2101  
TA-18

**"Response to Notice of Deficiency Concerning  
Operable Unit 1093 Field Investigation Work Plan"**

LIST OF DEFICIENCIES, DISCUSSION, AND  
PROPOSED TEXT CHANGES  
RFI WORK PLAN FOR OPERABLE UNIT 1093

Figure 5-8. Proposed sampling locations along sanitary sewer line from TA-18.

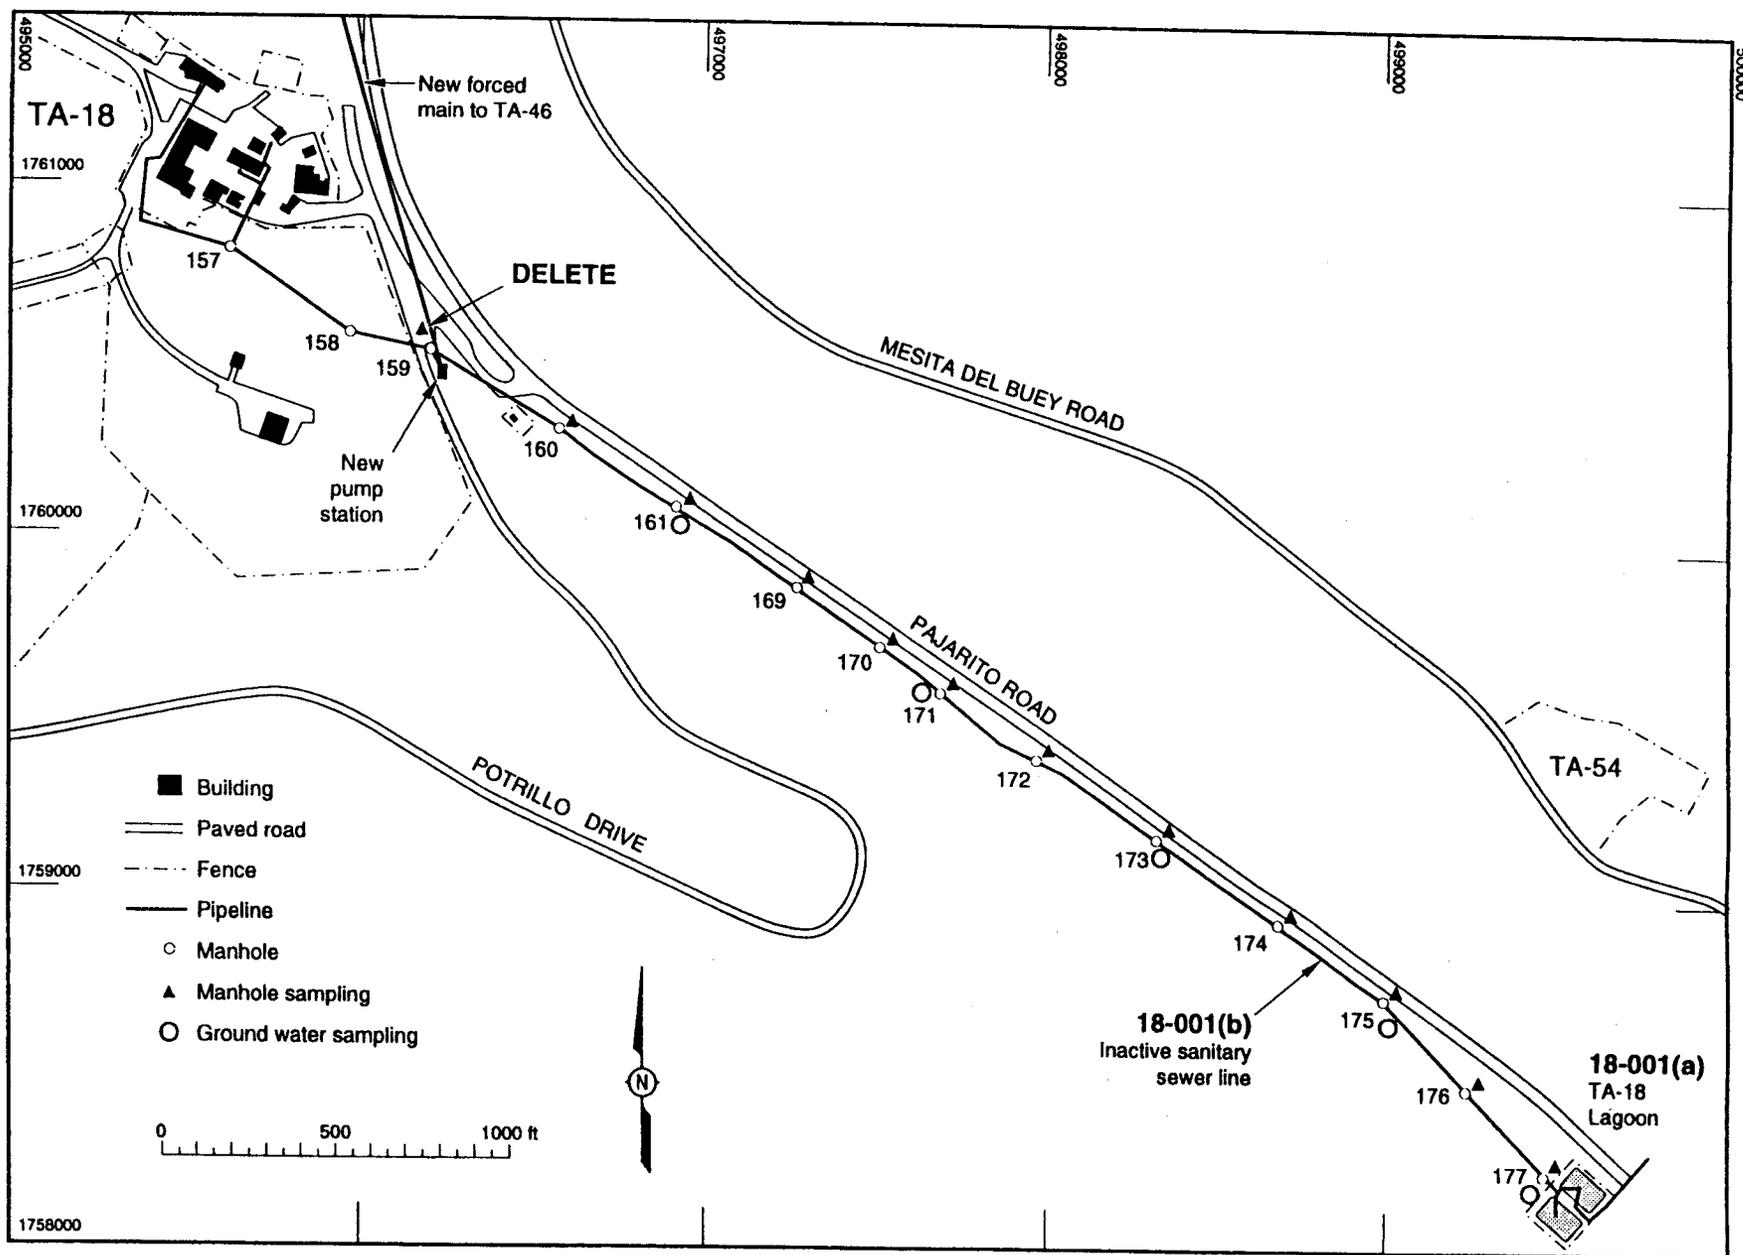
*The number of manholes to be sampled (12) shown in Figure 5-8 does not match the number of samples to be collected in Table 5-4 (11) LANL shall clarify how many manholes are to be sampled.*

Figure 5-8 incorrectly indicates that Manhole No. 159 will be sampled. Only manholes in the inactive portion of the line were scheduled for sampling.

See revised Figure 5-8.

Figure 5-16. Proposed sampling locations near firing sites in former TA-27.

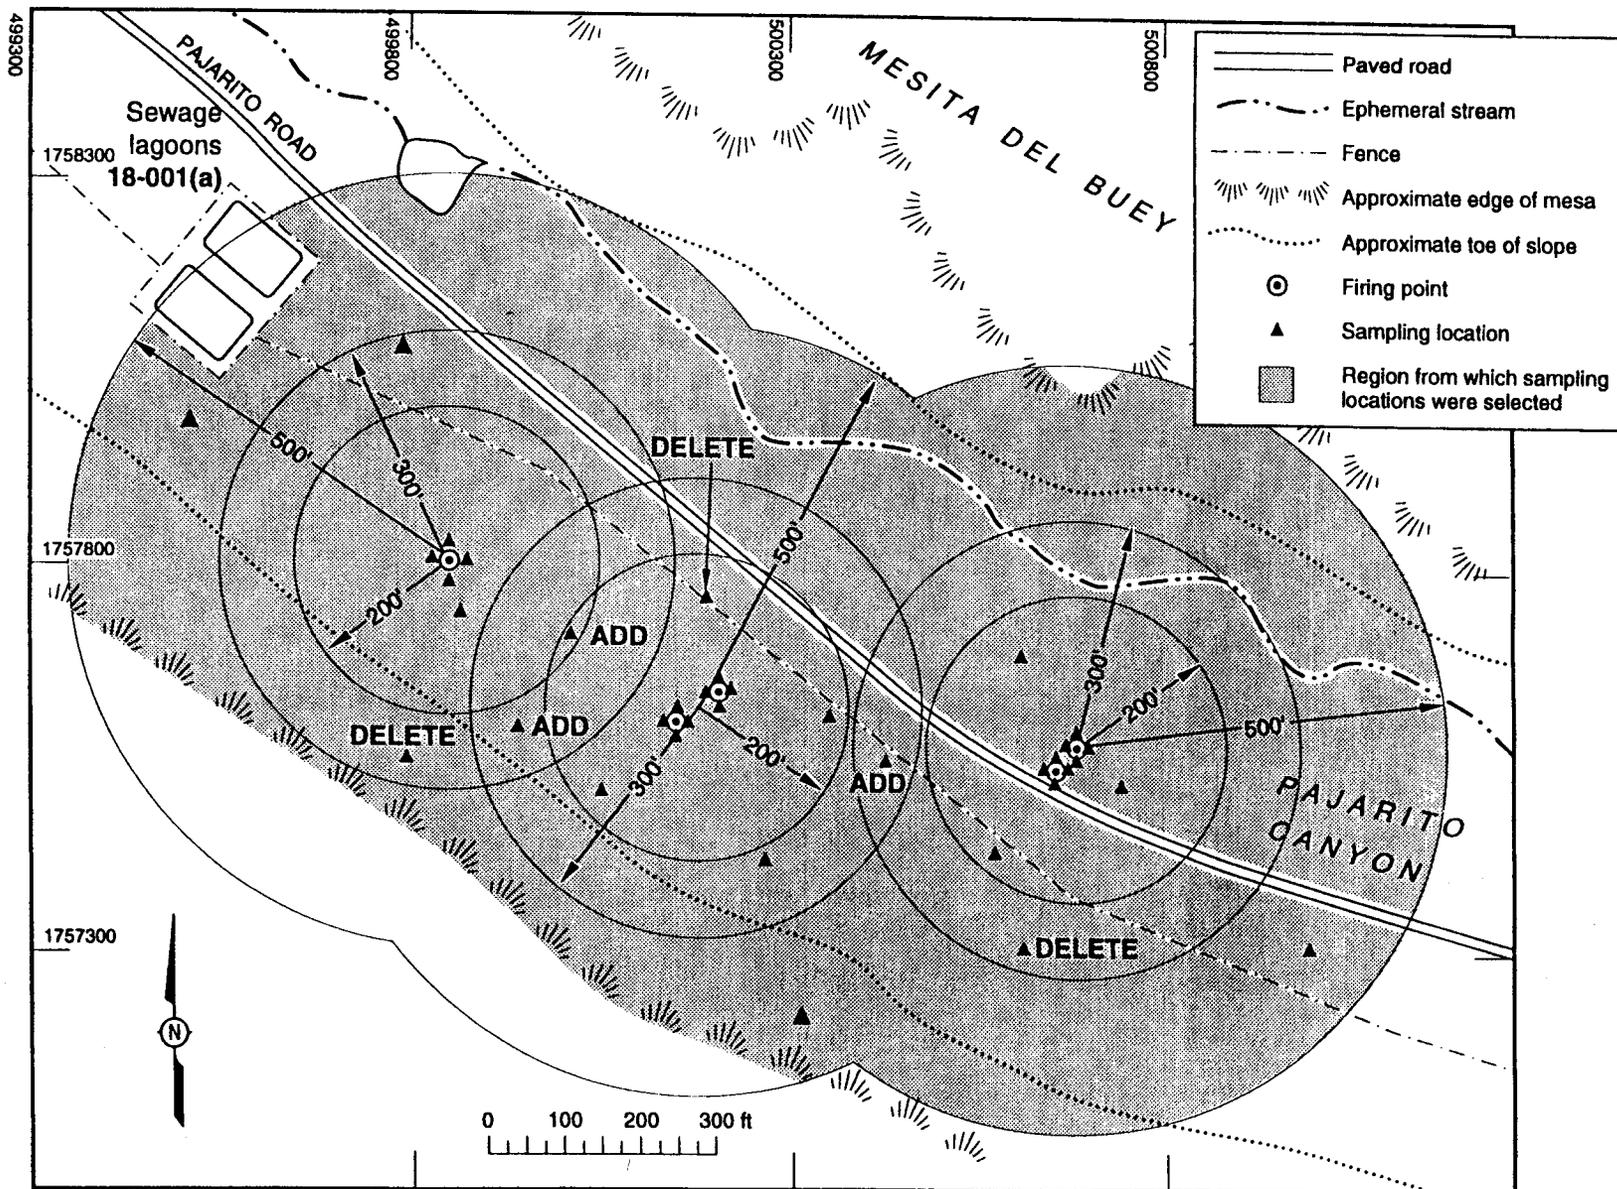
*LANL shall revise the proposed sampling locations so that the overlapping areas outside the actual firing points will be preferentially sampled.*

Agree. Figures 5-15 and 5-16 have been revised to show suggested changes in sample locations.

See attached revised Figures 5-15 and 5-16.
